Amendments to the Drawings:

Appl'n No. 10/053,582
Amd't Dated Mar. 9, 2005
Reply to Office Action of Dec. 9, 2004
Annotated Sheet Showing Changes

Fig. 3 ← RENUMBER
FIG. 2 SUBMITTED
08/10/04, AS FIG. 3

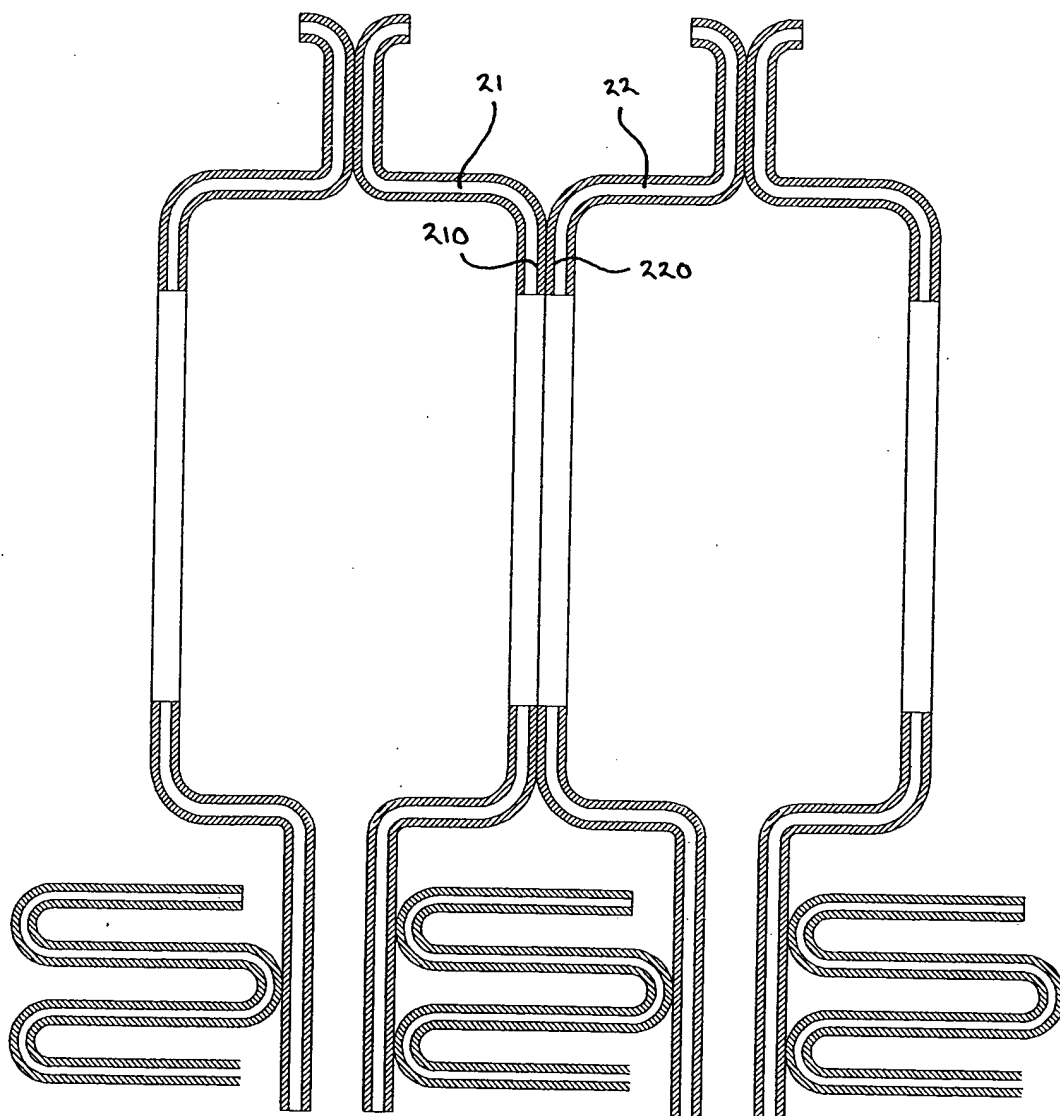
The attached sheet of drawings relabels the “**Fig. 2,**” which was submitted in the Responsive Amendment filed August 10, 2004, as **Fig. 3**. The “**Fig. 2**” submitted on August 10, 2004, was improperly labeled because a **Fig. 2** had been submitted previously. This sheet, which includes relabeled **Fig. 3**, replaces the previously submitted sheet including improperly labeled “**Fig. 2.**”
